### Agreement No. CE 45/2008 (CE)

### Liantang/Heung Yuen Wai Boundary Control Point and Associated Works – Investigation Final Report on Air Ventilation Assessment (Expert Evaluation) Report No.255228/06.028B

Final Report on Air Ventilation Assessment (Expert Evaluation) Report No.255228/06.028B

### Draft Report on Air Ventilation Assessment (Rev. A)

Figure 1.2: Computer generated 3D model of the Baseline Scenario

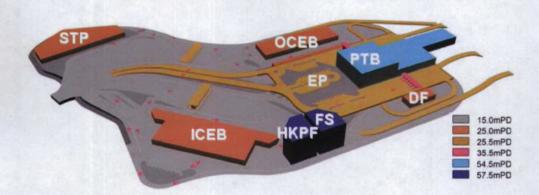
2. I captioned	have the following comments on the lireport:			
	Clause 1.5.4			
(a)	It is noted that HKPF Building and Fire Station are the tallest building/structures within the BCP site. Please check whether it is the requirement of HKPF and FSD.	<ul><li>HKPF confirmed that the HKPF will have an observation tower at the highest point of the site for security surveillance.</li><li>FSD confirmed that the tallest structure within the Fire Station Compound would be the drill tower. The drill tower may reach up to 30-35m in height and will be an independent structure within the compound.</li></ul>
